SK#31
03-06-2026

PROJECT OWNER : CK CAPITAL, LLC
PROJECT DESCRIPTION : CLEVELAND BROTHERS-MILESBURG
PROJECT ADDRESS : 4025N. EAGLE VALLEY ROAD, HOWARD, PA 16841
CONTRACTOR : KINSLEY CONSTRUCTION, INC.

DRAWN BY : BAS	DATE : 5-20-25	PROJ. NO. : 25912	REV # B
CHECKED BY : SRP	DATE : 5-20-25	DWG NO. : E703

DWG DESCRIPTION : GUARDRAIL & LADDER PLAN

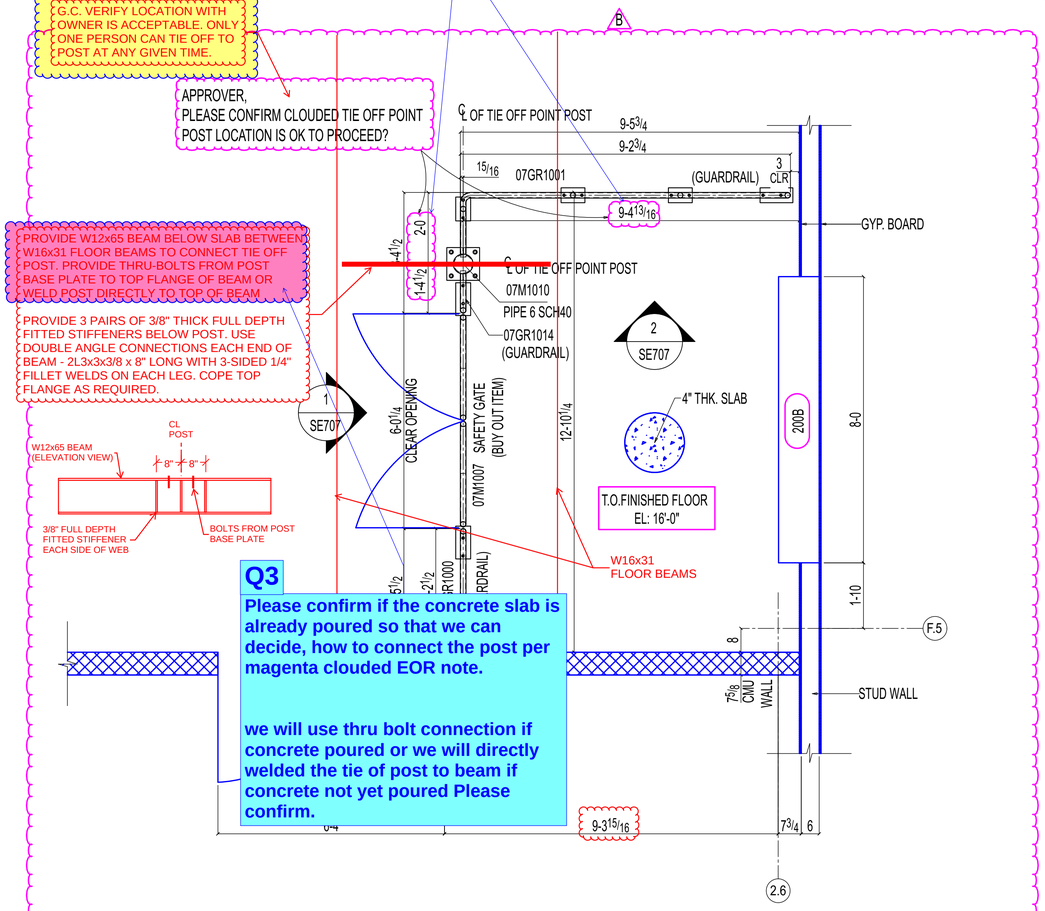
Q1

Please review the yellow clouded note and advise.

G.C. VERIFY LOCATION WITH OWNER IS ACCEPTABLE. ONLY ONE PERSON CAN TIE OFF TO POST AT ANY GIVEN TIME.

APPROVER,
PLEASE CONFIRM CLOUDED TIE OFF POINT POST LOCATION IS OK TO PROCEED?

PROVIDE W12x65 BEAM BELOW SLAB BETWEEN W16x31 FLOOR BEAMS TO CONNECT TIE OFF POST. PROVIDE THRU-BOLTS FROM POST BASE PLATE TO TOP FLANGE OF BEAM OR WELD POST DIRECTLY TO TOP OF BEAM

PROVIDE 3 PAIRS OF 3/8" THICK FULL DEPTH FITTED STIFFENERS BELOW POST. USE DOUBLE ANGLE CONNECTIONS EACH END OF BEAM - 2L3x3x3/8 x 8" LONG WITH 3-SIDED 1/4" FILLET WELDS ON EACH LEG. COPE TOP FLANGE AS REQUIRED.

1 / E703 MEZZANINE GUARDRAIL PLAN

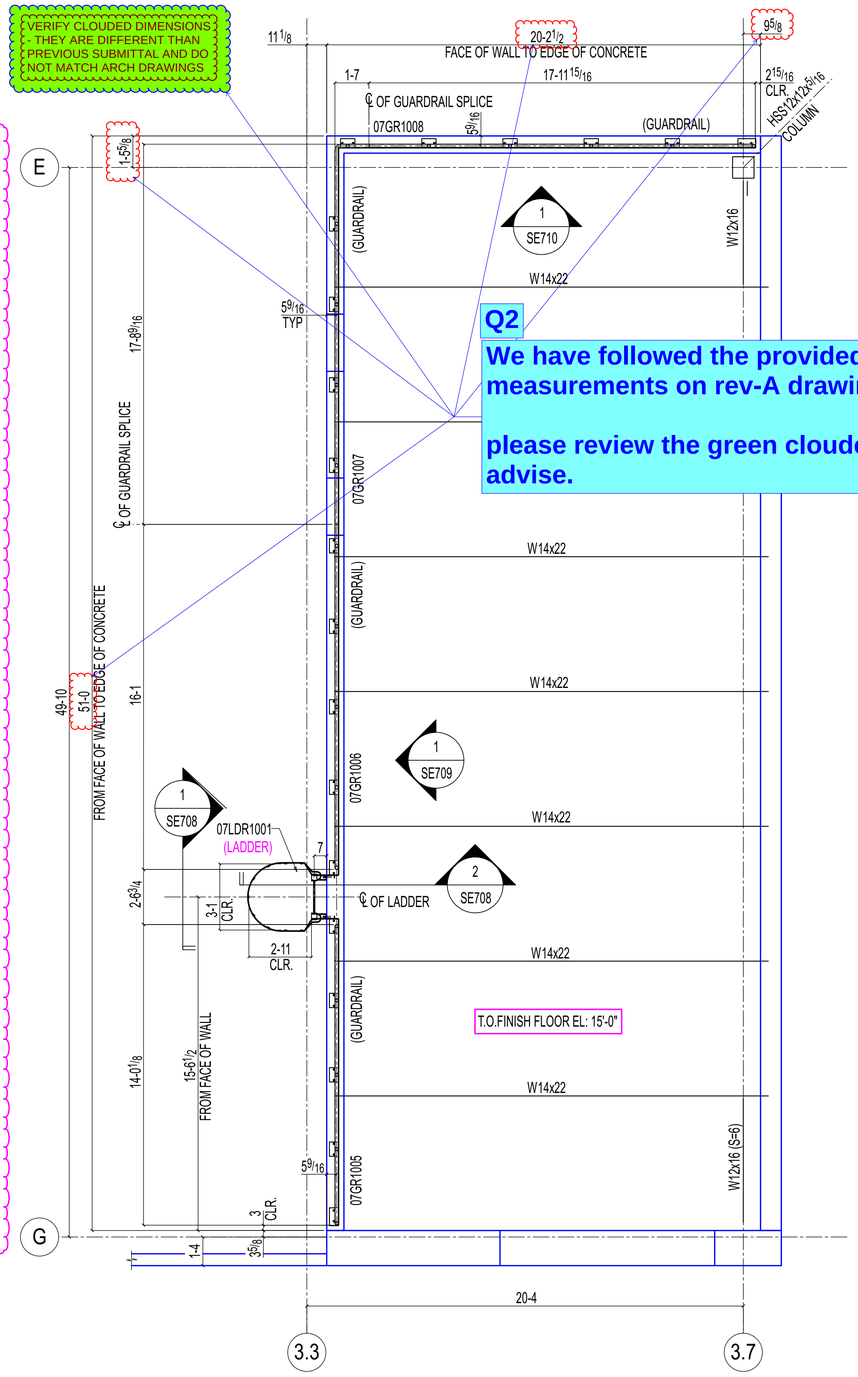
VERIFY CLOUDED DIMENSIONS - THEY ARE DIFFERENT THAN PREVIOUS SUBMITTAL AND DO NOT MATCH ARCH DRAWINGS

Q2

We have followed the provided field measurements on rev-A drawings.

please review the green clouded note and advise.

1 SE707 ELEVATION VIEW

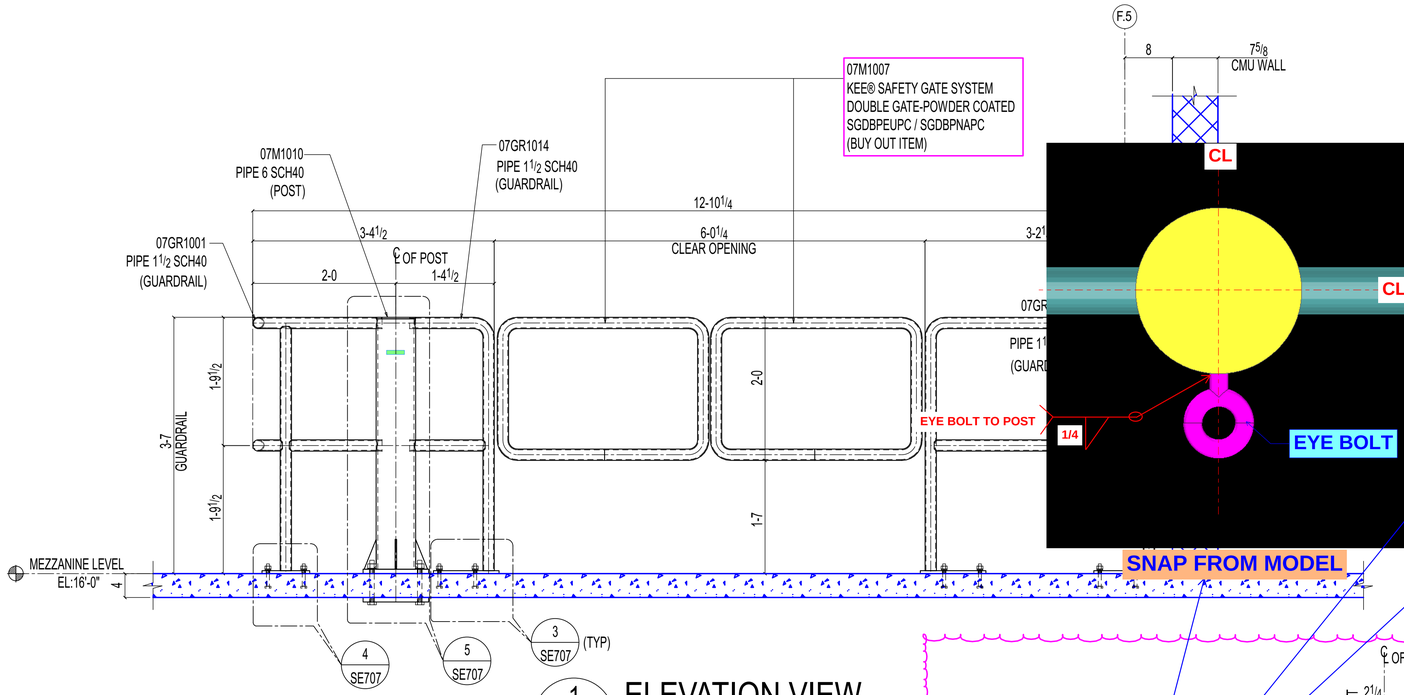
Q3

Please confirm if the concrete slab is already poured so that we can decide, how to connect the post per magenta clouded EOR note.

we will use thru bolt connection if concrete poured or we will directly welded the tie of post to beam if concrete not yet poured Please confirm.

APPROVER,
PLEASE REVIEW SHOWN TIE OFF POINT SUPPORT ARRANGEMENT AND LET US KNOW IF ANY ADDITIONAL STEEL REQURED FOR THIS.

5 SE707 DETAIL

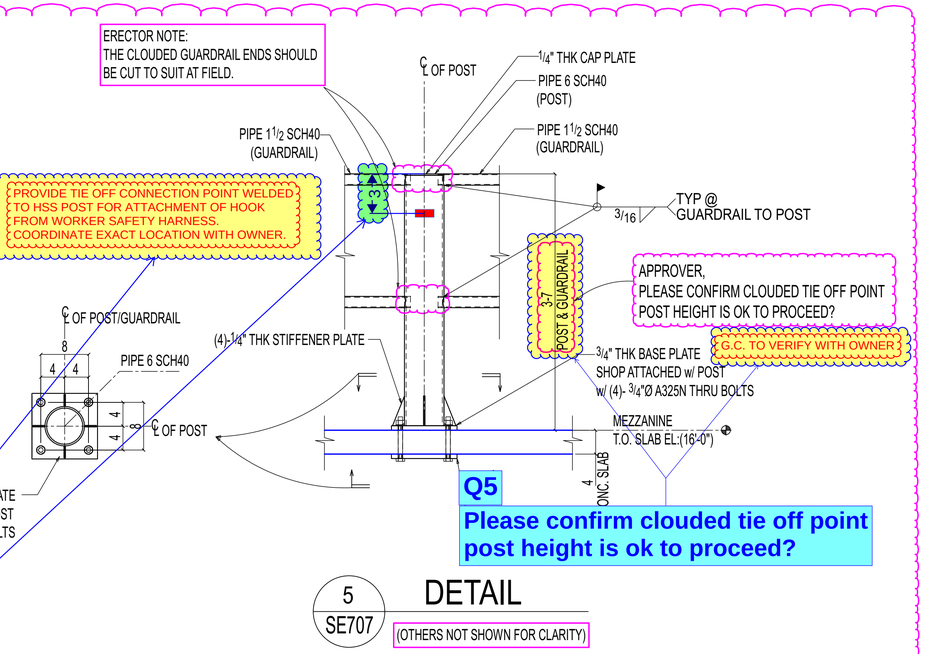
Q4

Per EOR comment, Please confirm the 3/4" Ø eye bolt details and the eye bolt location (green clouded) are OK to proceed?

Q5

Please confirm clouded tie off point post height is ok to proceed?
